# Town of Paradise Valley

## Meeting Notice and Agenda Planning Commission

B. [17-260](#) **Discussion of Hillside Code Updates (Article XXII of the Town Zoning Ordinance)**

Discussion of Draft Visually Significant Corridors Master Plan (VSC)

FIGURE 5 – BUILDING HEIGHT IN HILLSIDE

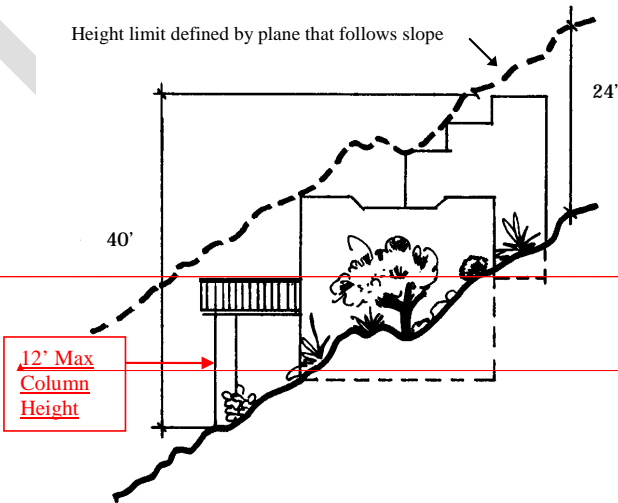
Comment [GB13]: Figure 5 to be updated to reflect these edits.

Comment [GB14]: Update Figure 5 to clarify measurement of 40' maximum height limit.

FIGURE 7 - HEIGHT FOR A CANTILEVERED ELEMENT

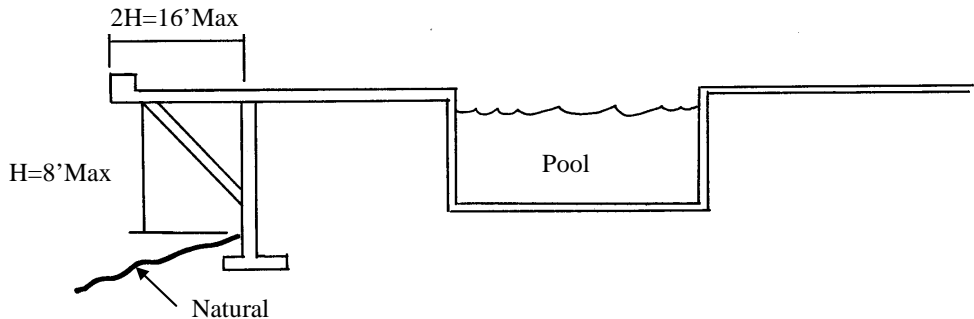
Comment [GB19]: Remove support from illustration on Figure 7.

FIGURE 8 –TERRACED VERTICAL RETAINING WALLS

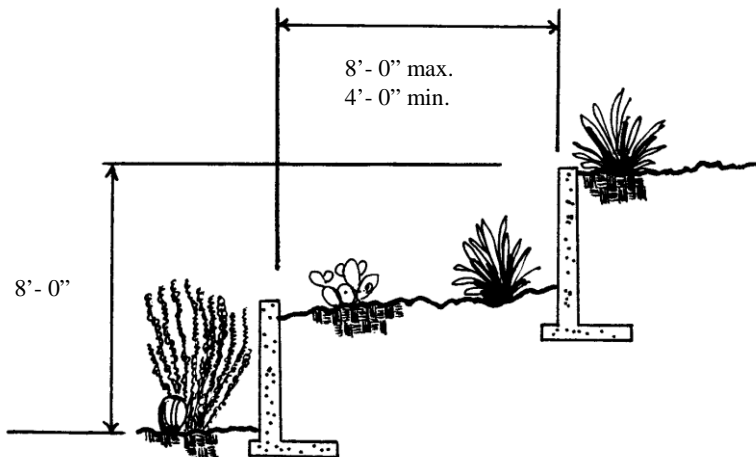
**Comment [GB32]:** Relocate Figure 8 below the text of 2207.VI.1.e.
